**F.1.a.f 1035 Joan Crescent: Update on Development Permit with Variance Application No. 00129 (Rockland)**

**Subject:** **Update on Development Permit with Variance Application No. 00129 for 1035 Joan Crescent**

Semi-Attached Dwellings Project - DEVELOPMENT VARIANCE PERMIT APPLICATION (REVISION 2)  
 24 September 2020

1 ROOF PLAN  
A3.01 1 : 100

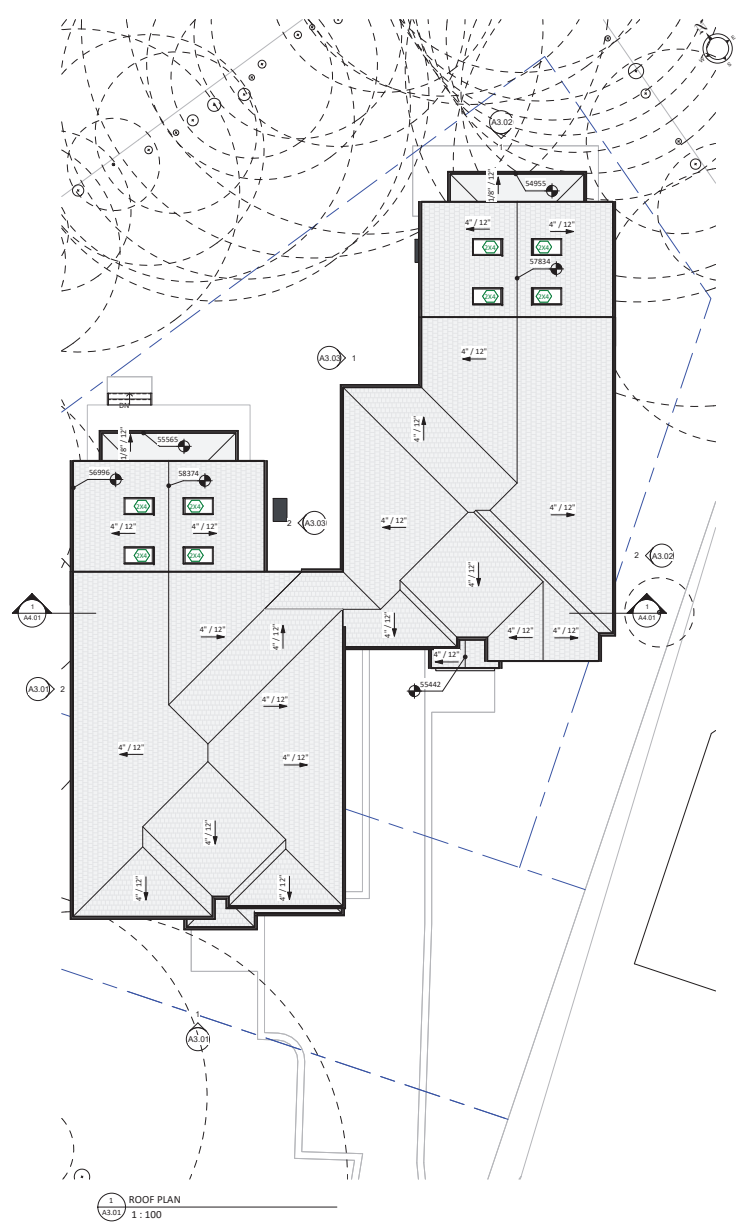
Further, while the Roof Plan, Page 8, 1-A3.01 appears to show a co-joined roof line the architects drawing of Page 1 clearly shows the main roof line is not joined.

The RNA LUC requests that Planning and Land Use Committee clarify the issue of the common- roof structure.

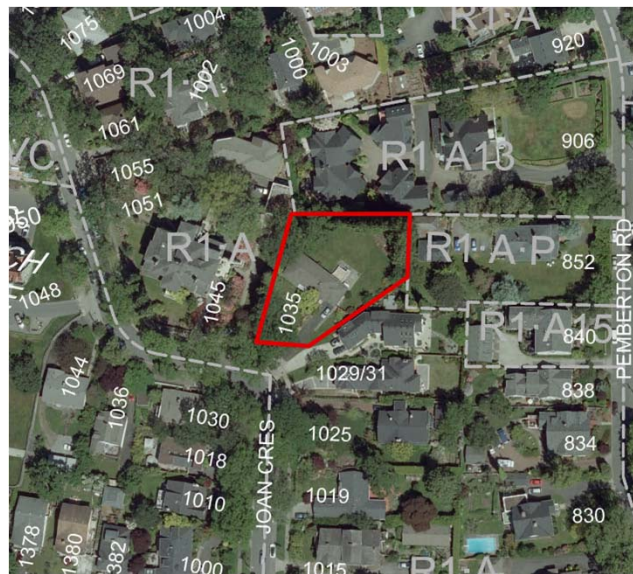
On November 18, 2019 we wrote to Mayor and Council questioning the application of the new R1-A zoning requirement of a common roof rather than the previous attachment of trellis, etc.

We appreciate that this designed was re-configured to include the now required "common roof"; an upgrade to the R1-A zone which we believe paves the way for all semi-attached residence's going forward.
